Draft Hart district Local Cycling and Walking Infrastructure Plan

Hart District Councillor comments – January 2024

In late January/early February 2024 Ward Councillors were invited to comment on the revised draft LCWIP, relating to the indicative interventions shown for their Ward. This document provides a summary of the comments made and a response to each one.

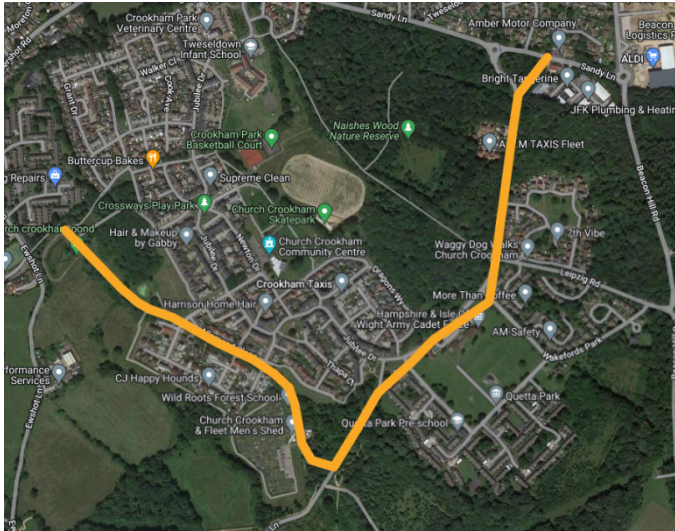
| Comment reference | Section of LCWIP | Issue raised | Response |
|-------------------|------------------|--|--|
| 01/07 | Route 160 | <p>Proposed the inclusion of a secondary route as shown below:</p>  | <p>Agreed.</p> <p>The LCWIP has been amended to include the new secondary route.</p> |

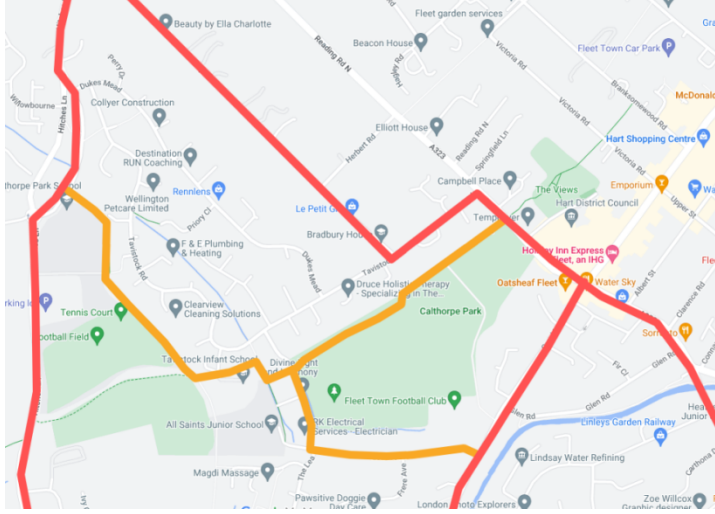
| Comment reference | Section of LCWIP | Issue raised | Response |
|-------------------------------------|---------------------------------|--|---|
| 02/03 | 140.10a | Proposes a 20mph speed limit in Guildford Road, in order to facilitate an alternative route option. We doubt that this would be a wise change to make, given the rest of that side of Pondtail, made up of small similar grid-style roads, would stay on 30mph. Motorists would find that confusing and potentially ignore it. | <p>In response to this point new text has been added to the introductory text at page 78 (introducing the proposed cycle network). The new paragraph states:</p> <p><i>“Implementation of cycle routes may use a variety of techniques. Where traffic volumes and speeds are higher, physically separated cycle tracks will be needed. On quieter streets, mixing cycling with motor traffic will often provide a suitable environment, but traffic speeds and volumes need to be low. Current guidance recommends a maximum speed limit of 20mph for mixed traffic, and this report follows that approach. Where individual streets are noted as requiring a 20mph limit, it may be more appropriate to cover a longer section, or several streets as part of a zone for consistency. This</i></p> |

| Comment reference | Section of LCWIP | Issue raised | Response |
|-------------------|--|--|---|
| | | | <p><i>would be addressed in more detail at the feasibility stage of any route.”</i></p> <p>The detail of any speed limit change would be subject to local consultation.</p> |

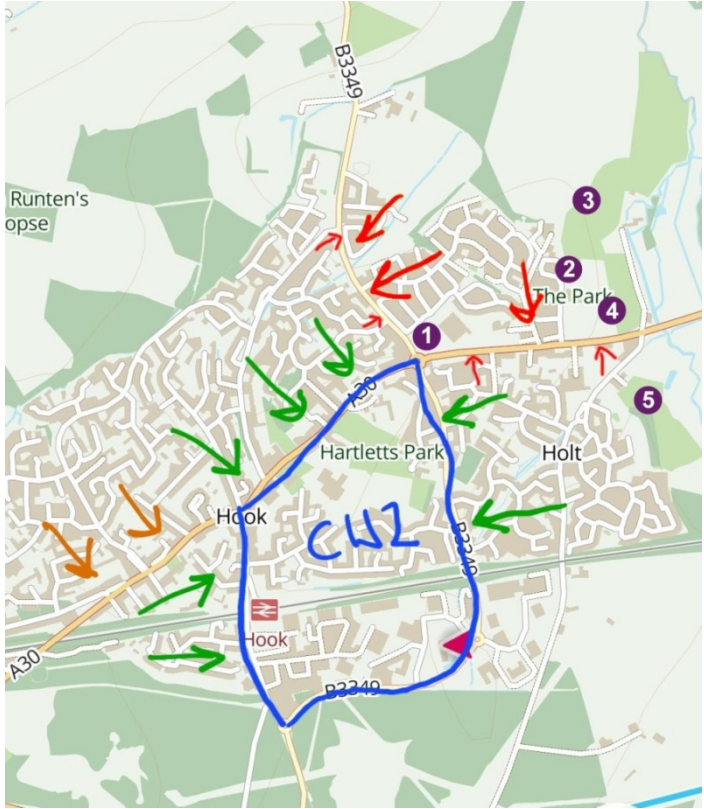
| Comment reference | Section of LCWIP | Issue raised | Response |
|-------------------|------------------|---|--|
| 04/03 | Z5.6 | Tightening the kerb radii at Weatherby Gardens would potentially hinder entry and access onto the A30. The junction is close to the A30/A323 (Fleet Road) roundabout, which is a busy junction. | <p>The revised draft of the LCWIP identifies why the indicative interventions are required. In this case, the intervention is identified because of a lack of pedestrian priority across the junction mouth.</p> <p>Reducing corner radii in locations like this reduces turning vehicle speeds, makes it easier for people to cross on foot by reducing the distance they must walk (this is particularly important for pedestrians who struggle with mobility) and allows crossing to follow desire lines more closely. This intervention follows national guidance and best practice and would be considered in a detailed feasibility assessment. This would include an assessment of the impact on vehicle turning movements, to ensure designs are</p> |

| Comment reference | Section of LCWIP | Issue raised | Response |
|-------------------|---|---|--|
| | | | suitable for the road conditions. |
